Amendments to the Drawings

Appl. No. 10/791, 969 Amdt. Dated Aug. 2, 2007 Reply to Office Action of Feb. 2, 2007 Annotated Sheet Showing Changes Made

FIG. 1

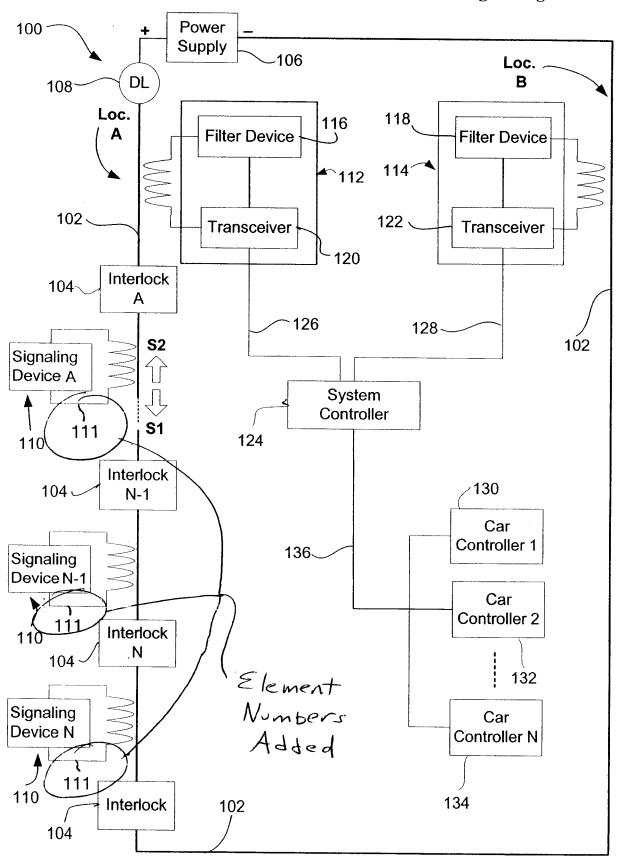
The Examiner has objected to the Drawings under 37 CFR § 1.83(a). Specifically, the Examiner requested that certain elements specified in the claims be shown in the Figures. Regarding the element "rf signals", Applicant has amended the specification (paragraph [0022]) and Figure 1 to include a reference numeral (111) for the rf signal (see Attached Replacement Sheet and Annotated Sheet).
